MIAMI BEACH  
PLANNING DEPARTMENT  
Staff Report & Recommendation

Design Review Board

SUBJECT: DRB0416-0015

**1600-1634 Alton Road "1212 Lincoln Road" – Commercial Development**

AA arena LED screen made of stainless steel mesh, the screen is 70 percent transparent

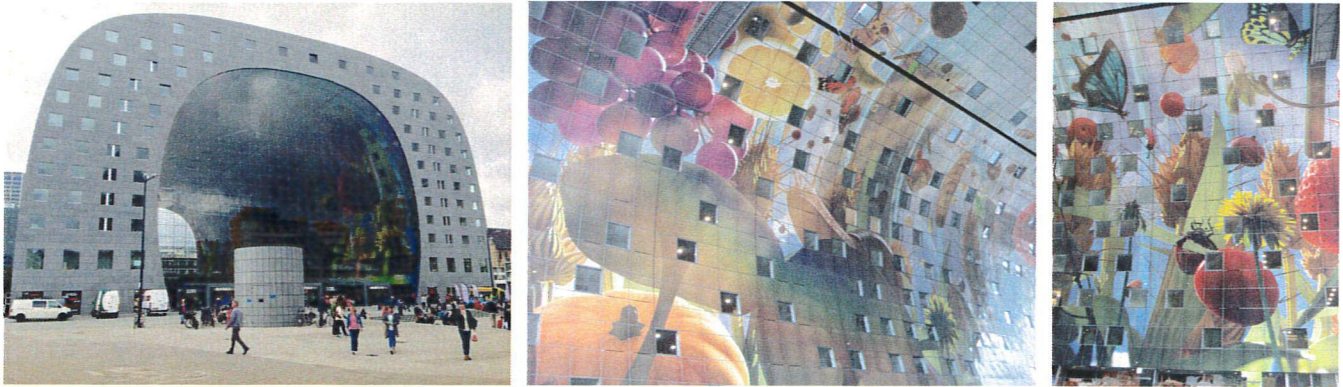
Staff's primary concern is the structural mechanism and digital display screens provided that conveys the electronic murals, graphics or images. The architect has selected two large LED boards to be attached to two blank walls within the exterior skin of the 'mercado' project. Staff believes along with advancement in architectural mesh lighting solutions, that the team is missing an opportunity to seamlessly blend the driving concept of the desired imagery into the skin of the architecture.

Staff recommends that the architect further explore more advanced display options in order to truly become a visual centerpiece for the City, serving as an innovative and bold stage as envisioned by the team. As such, staff recommends the application be continued to a future date, with specific direction to address the issues and concerns raised herein.

- b. The proposed digital LED screens **shall not** be approved as proposed. The architect shall incorporate a technology that blends moving imagery and graphics to architecture in a more refined and advanced method, details shall be submitted in a manner to be reviewed and approved by the Board.
